Project	IEEE 802.16 Broadband Wireless Access Working Group < http://ieee802.org/16 >	
Title	Technical and editorial amendment of 802.16-2004 facilitating license-exempt and uncoordinated band operation	
Date Submitted	2006-01-03	
Source(s)	Paul Piggin Cygnus Communications 2075 Las Palmas Drive Carlsbad CA 92009	Voice: 760 448 1984 Fax: 760 448 1989 ppiggin [at] cygnuscom.com
Re:	Call for Contributions, IEEE 802.16h Task Group on License-Exempt Coexistence, IEEE 802.16h-05/023	
Abstract	This document contains suggested amendments to the working draft and base standard to facilitate a framework from which MAC enhancements for license-exempt and uncoordinated system operation can be developed.	
Purpose		
Notice	This document has been prepared to assist IEEE 802.16. It is offered as a basis for discussion and is not binding on the contributing individual(s) or organization(s). The material in this document is subject to change in form and content after further study. The contributor(s) reserve(s) the right to add, amend or withdraw material contained herein.

Technical and editorial amendment of 802.16-2004 facilitating license-exempt and uncoordinated band operation

Figure xyz Representation of 'Channel Centre Frequency' calculation.

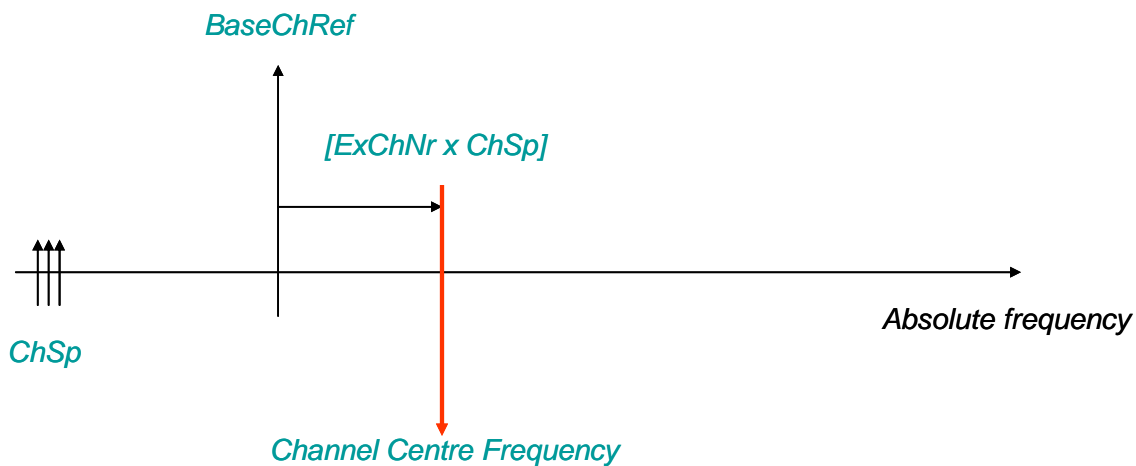
In summary the definition of the *Channel Centre Frequency* is:

$$\text{Channel Centre Frequency [MHz]} = \text{BaseChRef [MHz]} + (\text{ExChNr [MHz]} \cdot \text{ChSp [200kHz]}) \quad [\text{xxx}]$$

This is shown in a graphical representation in figures [xyz].

Figure 219—Illustration of OFDMA frame with multiple zones

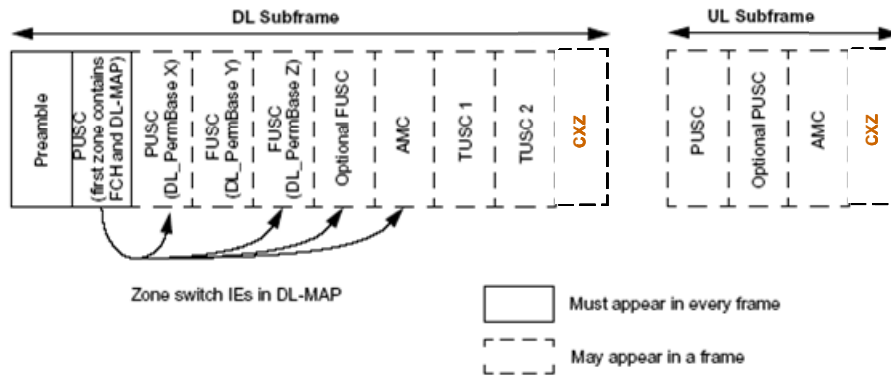
In support of the material added in section 6.4.2 make the following changes to the OFDMA PHY specification in figure 219 in section 8.4.4.2.

The OFDMA frame may include multiple zones (such as PUSC, FUSC, PUSC with all subchannels, optional FUSC, and AMC, **CXZ**, TUSC1, and TUSC2), the transition between zones is indicated in the DL-Map by the STC_DL_Zone IE (see 8.4.5.3.4), **CXZ_DL_IE** (see 8.4.5.3.11), or AAS_DL_IE (see 8.4.5.3.3). No DL-MAP or UL-MAP allocations can span over multiple zones. Figure 219 depicts the OFDMA frame with multiple zones.
